CORRIGENDUM - 10 TO NIT NO-99909

Subject: Corrigendum-10 to Tender enquiry for Pre-Bid Tie up with the GIS OEM for Supply & Services of 400KV & 220KVGIS for NPCIL's Kundankulam Unit 5&6 Sub-Station Tender / Project.

Ref. No.: Technical Corrigendum No. 03

Project: Pre-Bid Tie up for Pre-Bid Tie up for,
400kV & 230kV GIS & GIBD systems of Nuclear Power Corporation of India Limited for Main Plant Electrical System Package for KKNPP Units- 5&6

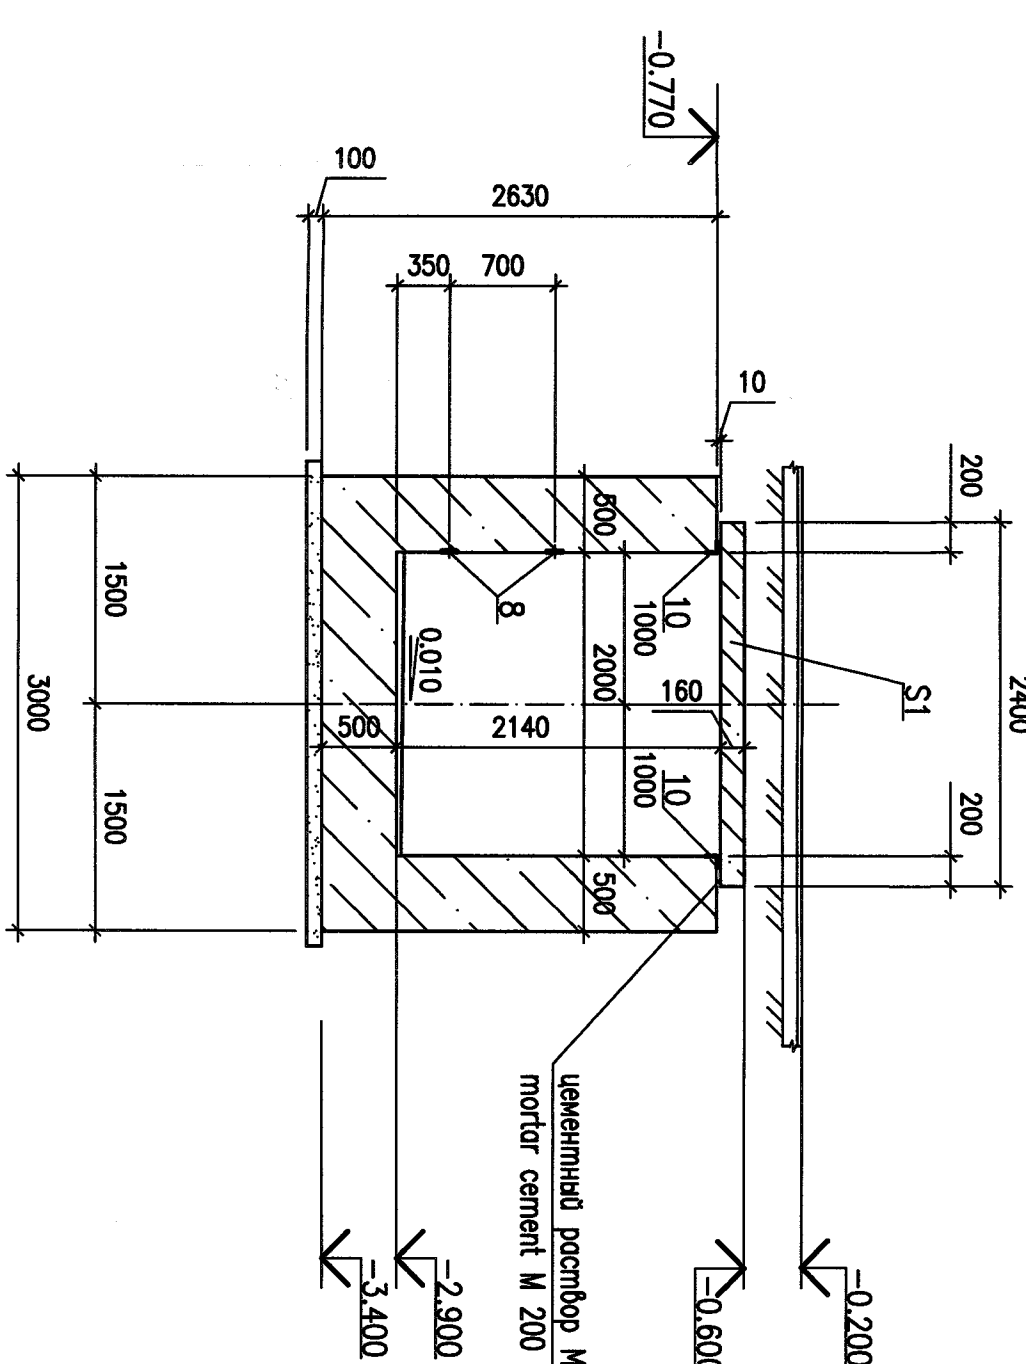
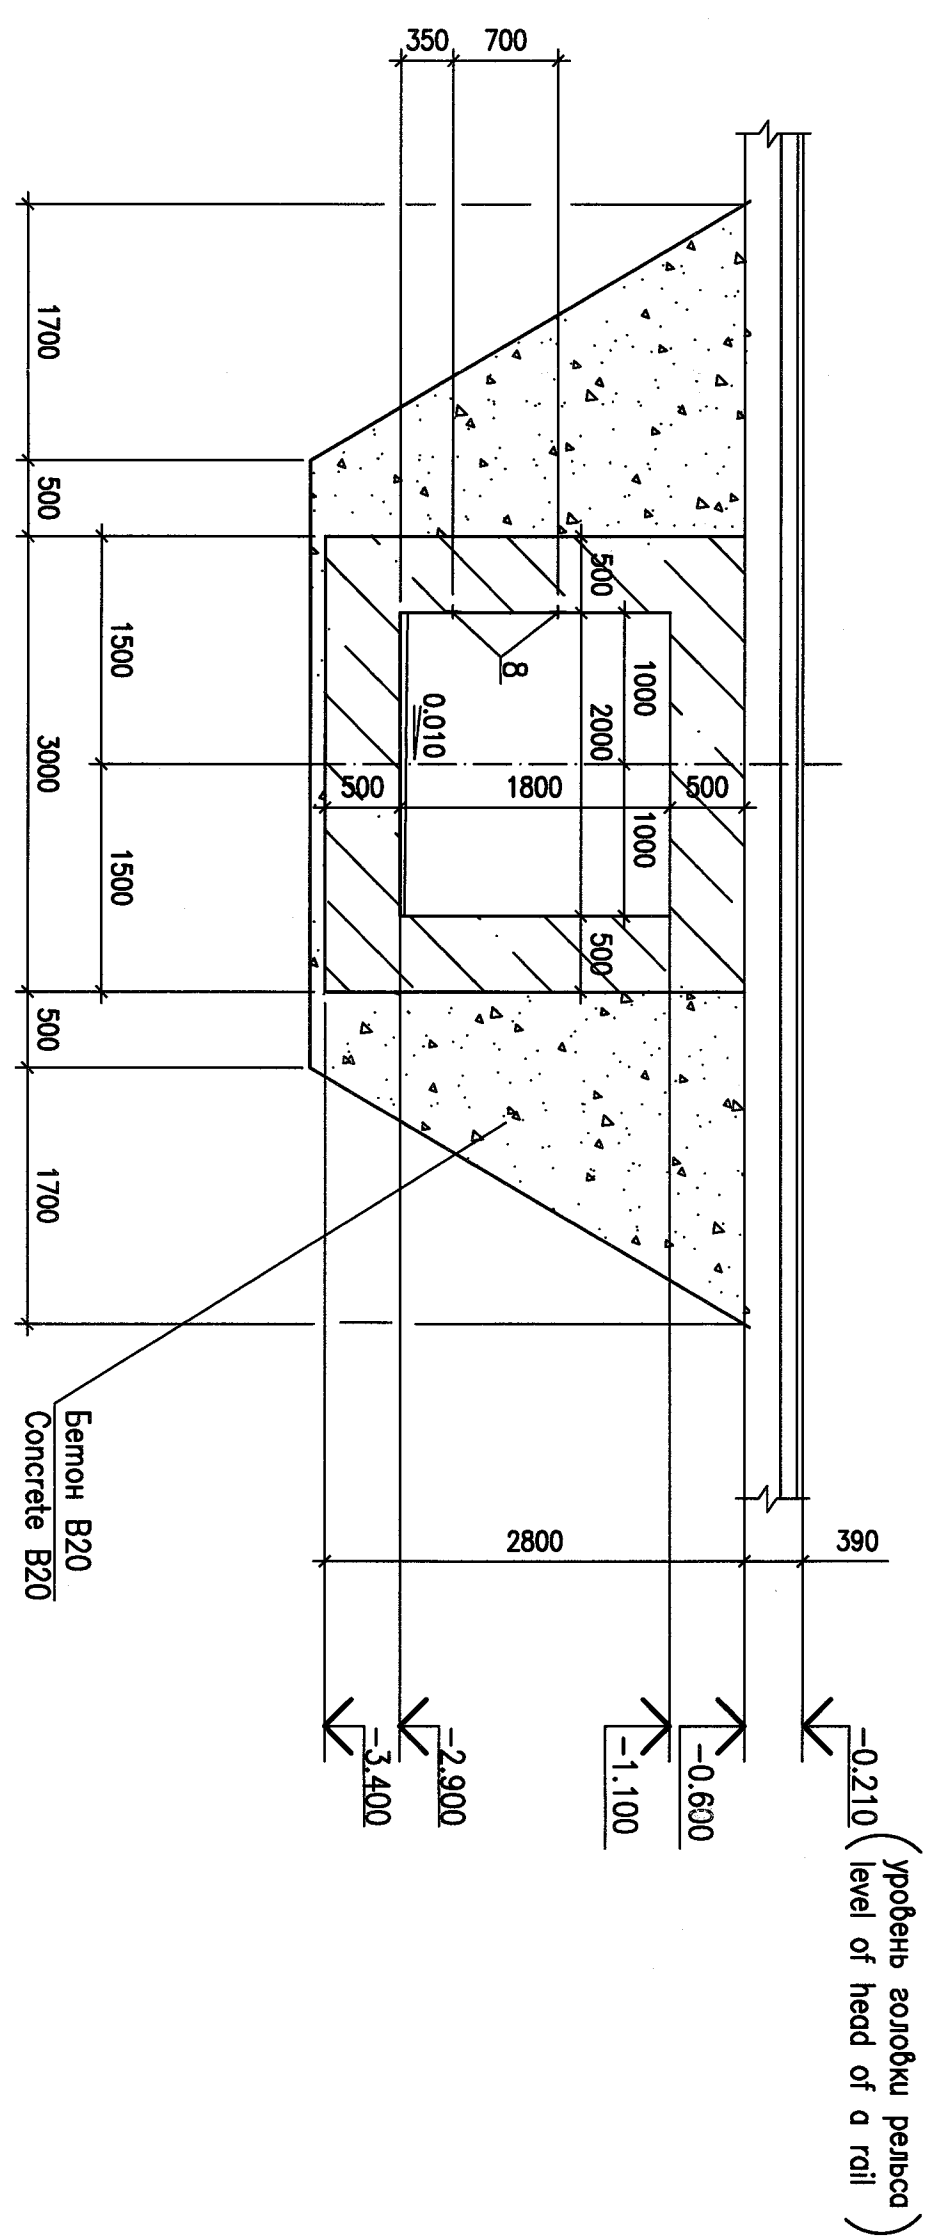
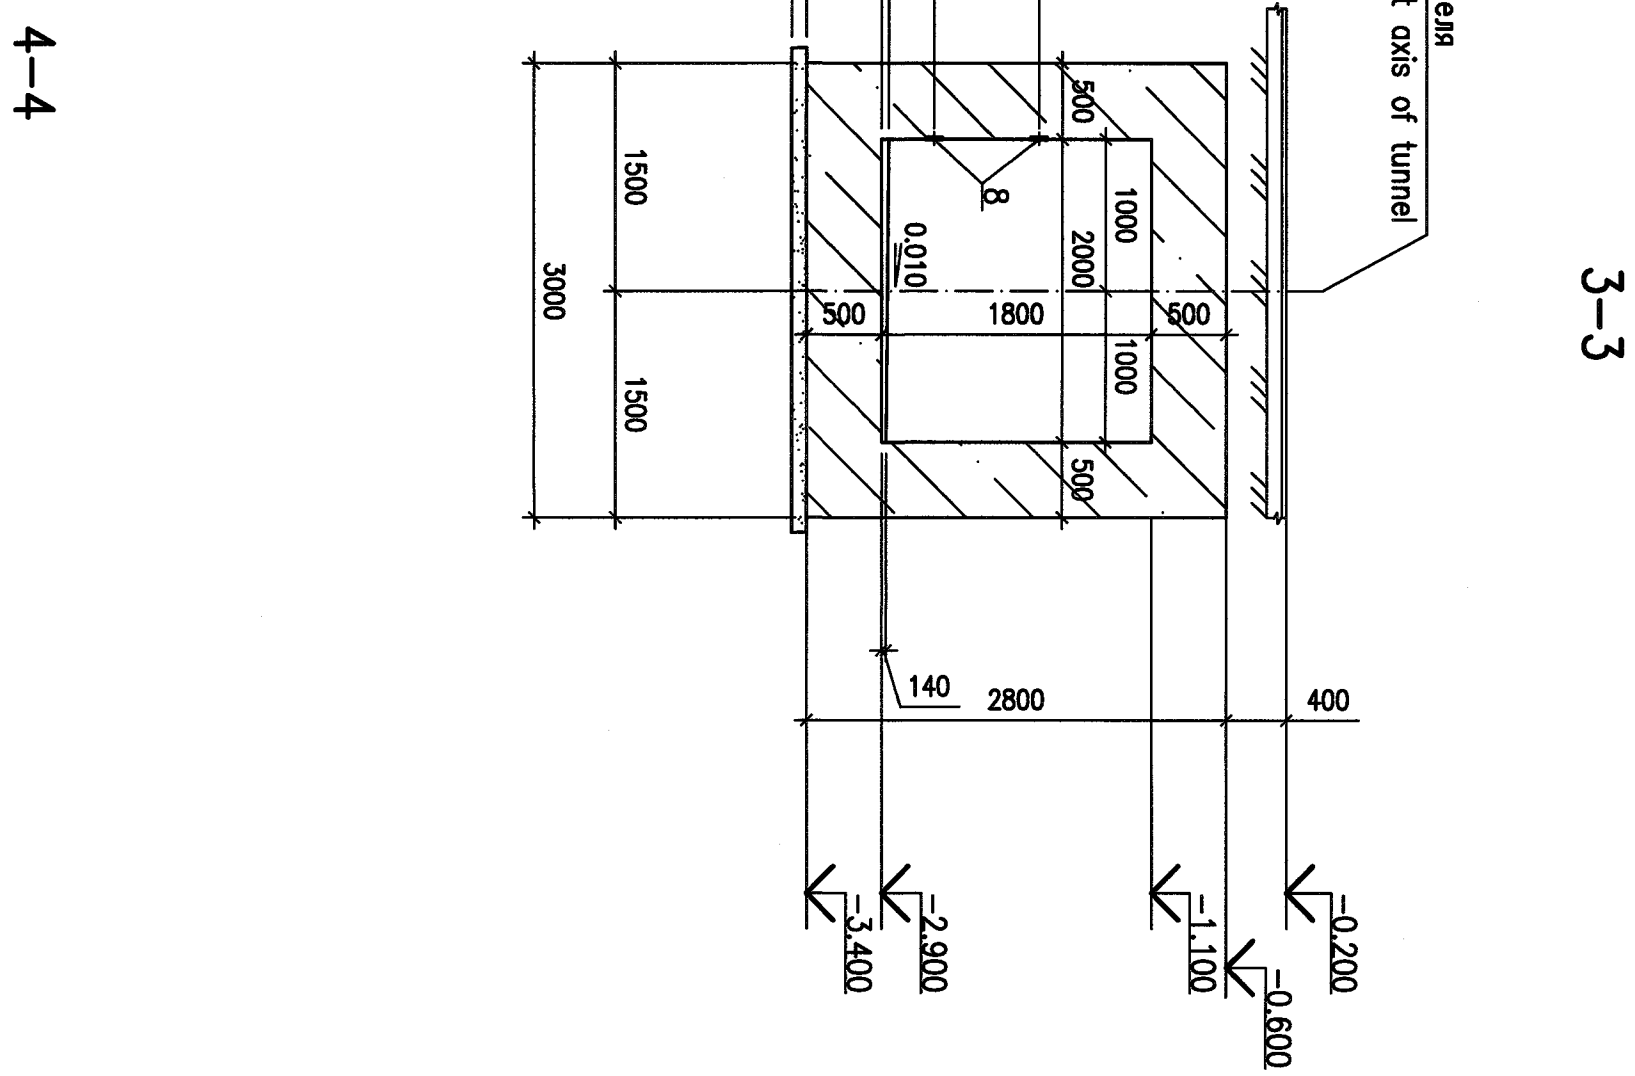
Sl. No.	Volume/ Section/ Clause	Volume/ Section/ Clause as Existing	Volume/ Section/ Clause as Amended/ Added in Technical Corrigendum
1	Technical Specification	Section-1	<i>Drawings & documents as Annexure-1 & Annexure-2 are attached. The above annexures are to be read in connection with Pre-bid Clarifications.</i>
2	-	-	<i>1. Pre-Bid Clarification- Response-4 to Tender No. CMM/MEQ/91-21-2-1219, Pre-Bid Clarification- Response-5 to Tender No. CMM/MEQ/91-21-2-1219 & Pre-Bid Clarification- Response-6 to Tender No. CMM/MEQ/91-21-2-1219 is attached.</i>
3	-	Additional Technical Requirements	<i>Zone tripping logic shall be developed in LCC/ Panel by GIS vendor, as required. Any contact multiplier and/or additional contacts required in density monitors shall be taken care by GIS vendor.</i>
